REMARKS

Claims 1 through 72 are pending in the application. Claims 1, 2, 5, 7, 10, 11, 14, 16, 19, 20, 23, 25, 28, 30 through 32, 39, 41 through 43, 50, 52 through 54 and 70 have been amended. Reconsideration of this application is respectfully requested.

FIG. 13

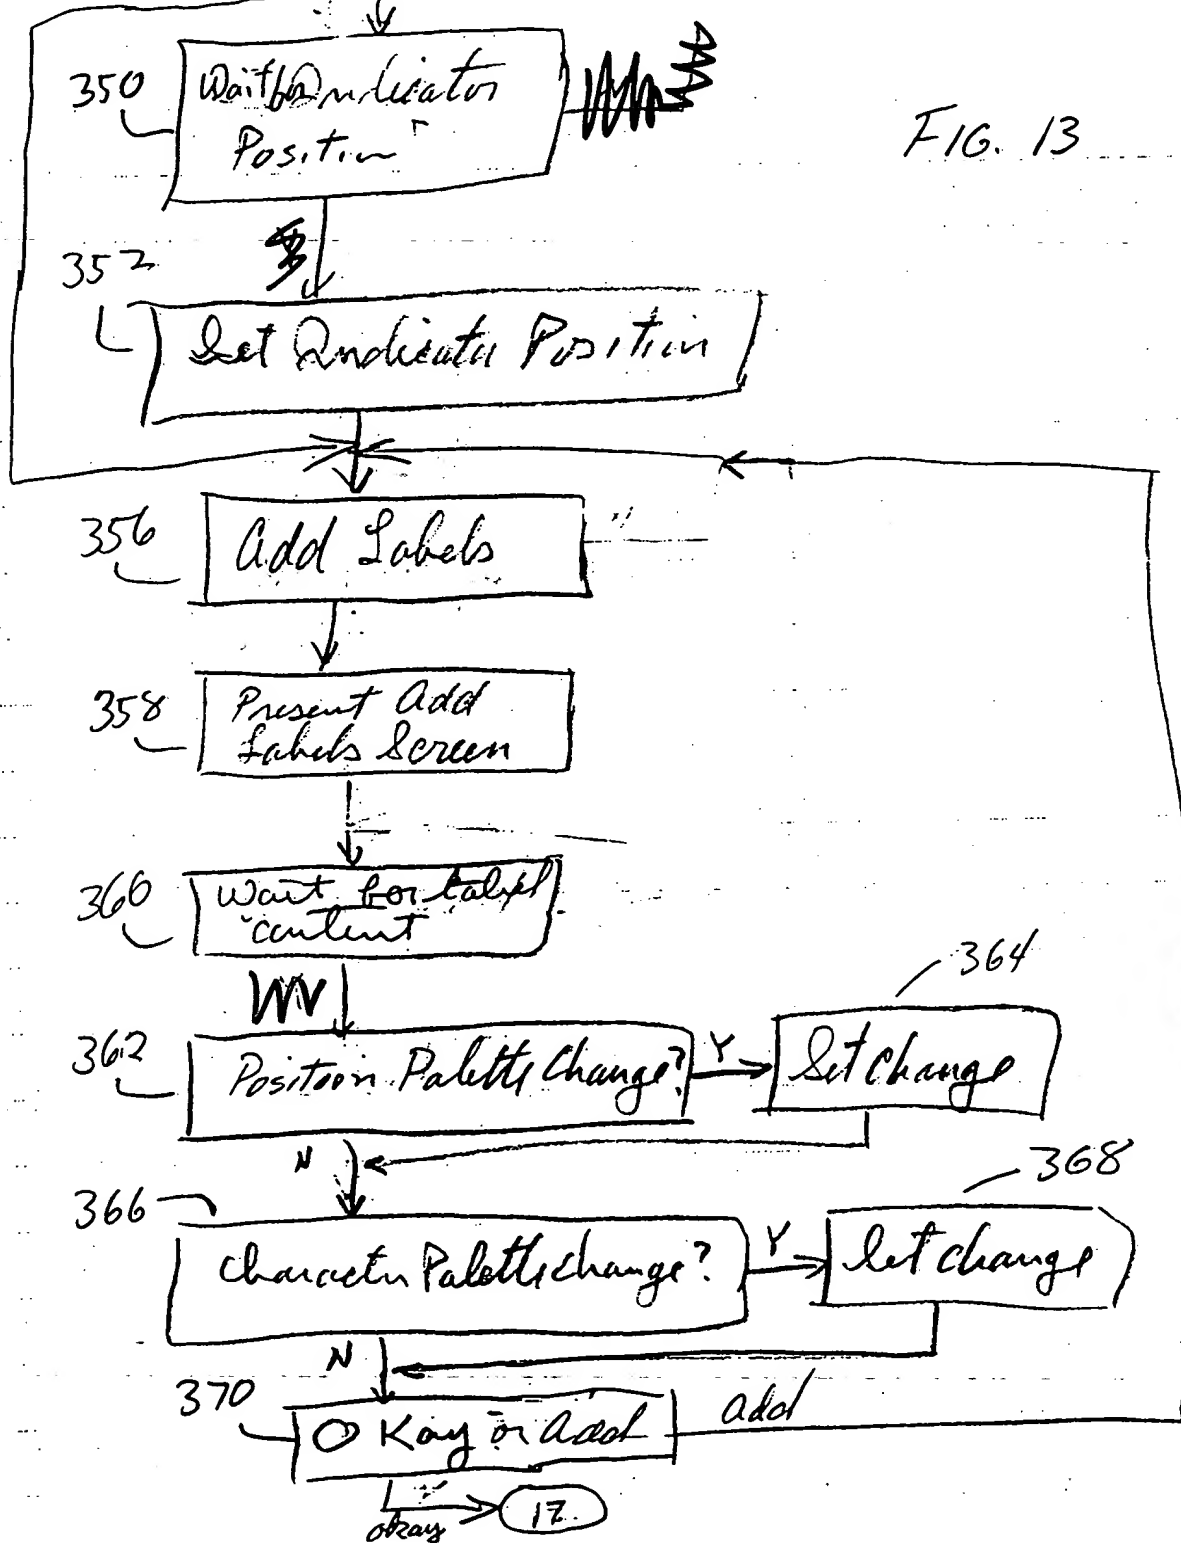
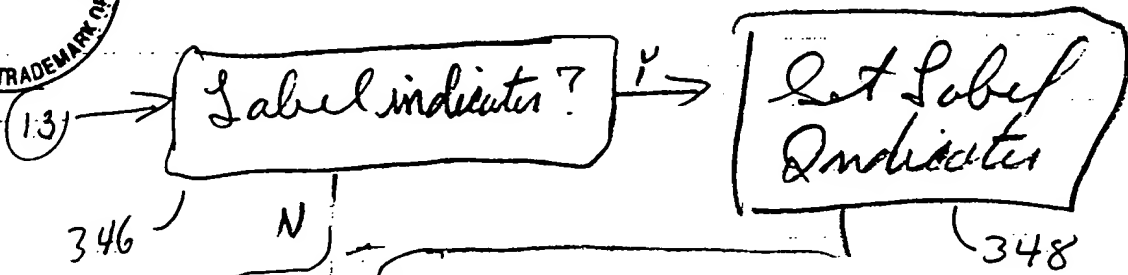
The Office Action has objected to the drawing because the "Y" legend adjacent box 360 in Fig. 13 should be deleted. Fig. 13 has been so amended by a replacement sheet appended hereto subject to the approval of the Examiner. Therefore, it is submitted that the objection to Fig. 13 of the drawing is obviated by the amendment and should be withdrawn.
